TVA-BFN-TS-431

BROWNS FERRY NUCLEAR PLANT (BFN) - UNIT 1 - TECHNICAL SPECIFICATIONS (TS) CHANGE TS-431, SUPPLEMENT 1 - EXTENDED POWER UPRATE (EPU)

TVA EVALUATION OF THE PROPOSED CHANGE

Figure 3.4.1-1
THERMAL POWER VERSUS CORE FLOW STABILITY REGIONS

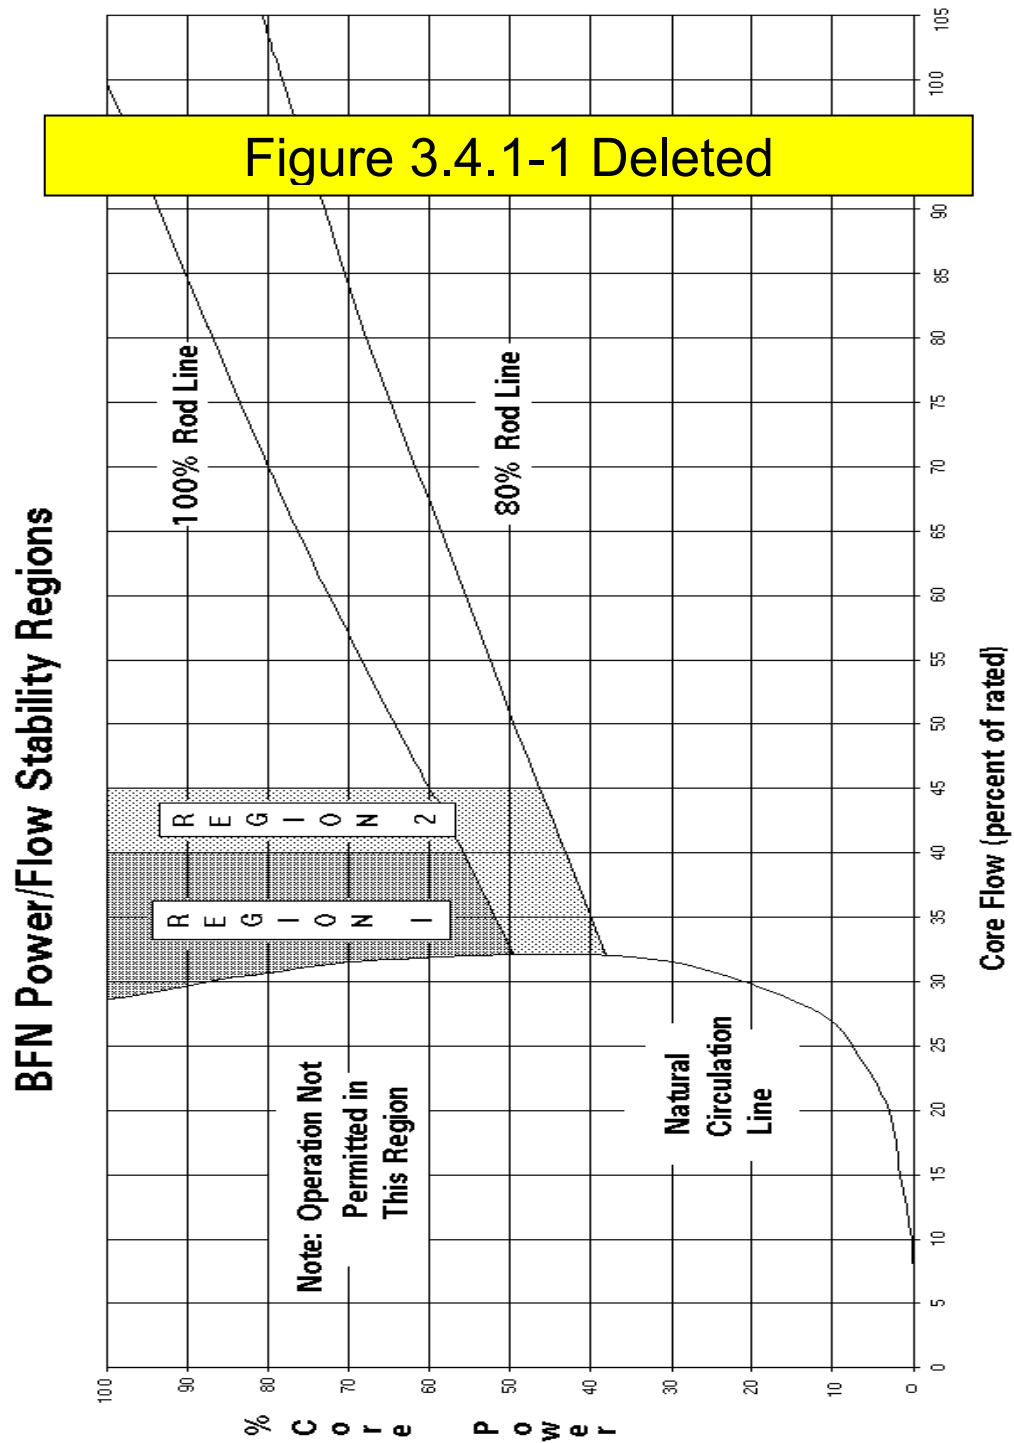
FIGURE 3.4.1-1 Deleted
